**Subject: SNM-1168 AMENDMENT REQUEST TO SUPPORT NEW CHEMISTRY SERVICES LABORATORY (CSL)**

Enclosure: I) Description of License Change  
II) Description of License Application Change Pages

Attachment: 1) Chapter 1 and Chapter 7 Change Pages

**AREVA NP INC. - MT. ATHOS ROAD FACILITY**  
**USNRC LICENSE SNM-1168, DOCKET 70-1201**  
**CHAPTER 1 – GENERAL INFORMATION**

Figure 2-1

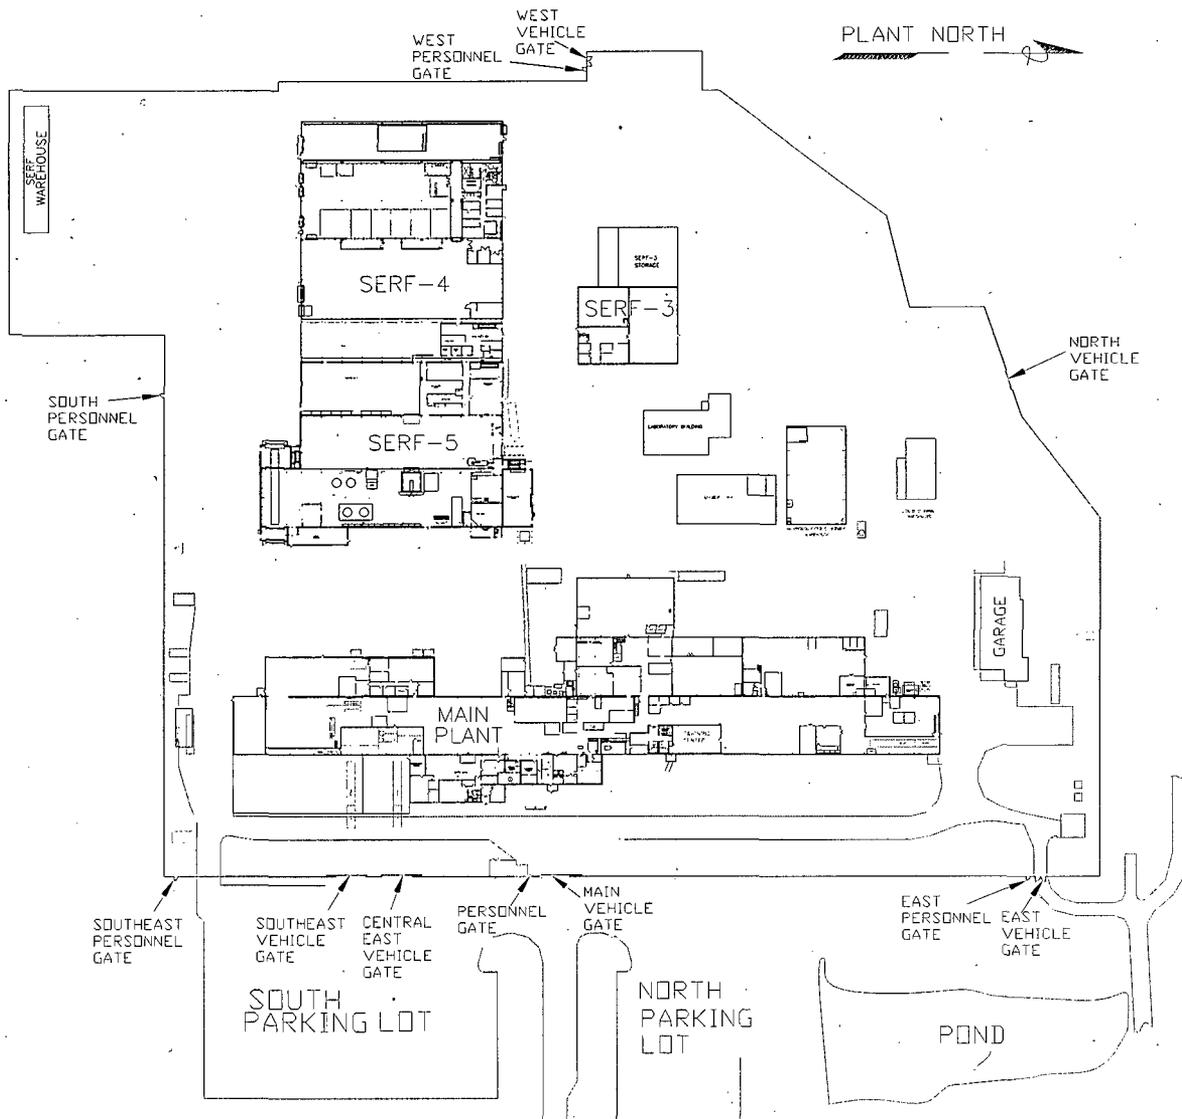
The CSL will be a stand-alone building located in approximately the center of the fenced portion of the Mt. Athos Road (MAR) site as shown in Figure 2-1.

Figure 1-1

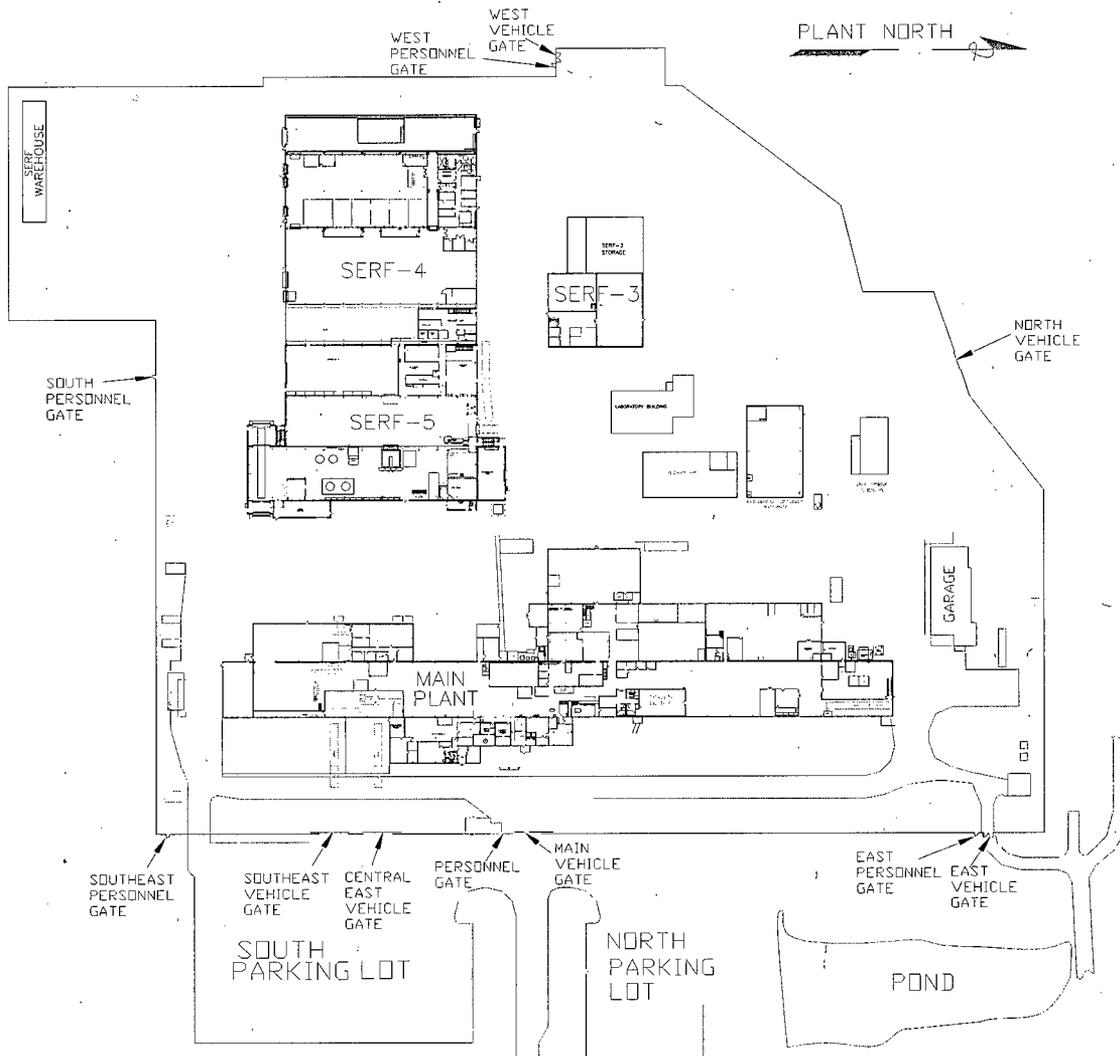
There are approximately 16 distinct buildings located at this site. General site layout is as shown in Figure 1-1. Fuel fabrication operations take place in the main process building. Activities related to work on equipment potentially contaminated with by-product material generally take place in SERF-3, SERF-4 and SERF-5. Laboratory operations with radioactive materials are performed in the CSL building. Site structures are generally constructed of concrete floors, a mixture of corrugated metal on steel and concrete or concrete block walls, with corrugated metal roof assemblies.
